Delegated Report

Householder Planning Application

Planning Application No: 20220876

Location: White Lodge Nash Street Meopham Gravesend

Existing Front Elevation

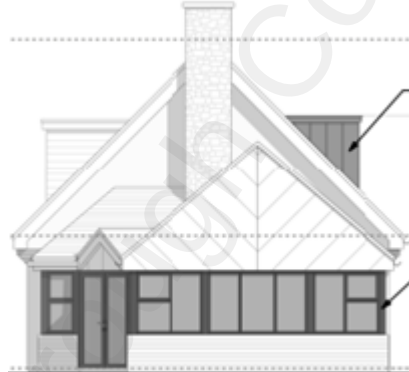
The proposal is for the remodel of the front entrance, front dormers, windows, and replacement of the roof tiles with demolition of the front and side porch. The replacement porch would project 850mm from the existing front elevation, be 3.64m wide and 5.58m in height and would replace the central front dormer. The two remaining front dormers would be replaced by a more contemporary design to match the proposed porch / glazed landing area, as well as the front windows and doors being replaced. The rear dormer would have replacement windows and grey cedar weatherboard to reflect the alterations to the front and the whole roof would be replaced with slate tiles.

Existing Right Side Elevation

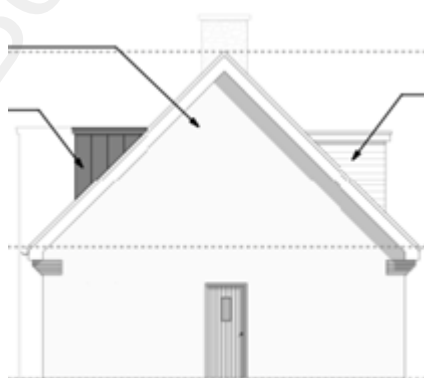
It has been stated on the application form and submitted drawings, that the proposal would result in a change of all the windows and doors, the whole roof being replaced with slate tiles and a change to the external materials of the dormers. Whilst they would not match the existing property, they proposed external materials would respect each other and would result in uniformity within the dwelling itself. The proposed materials are therefore considered to be acceptable when viewed as a whole.
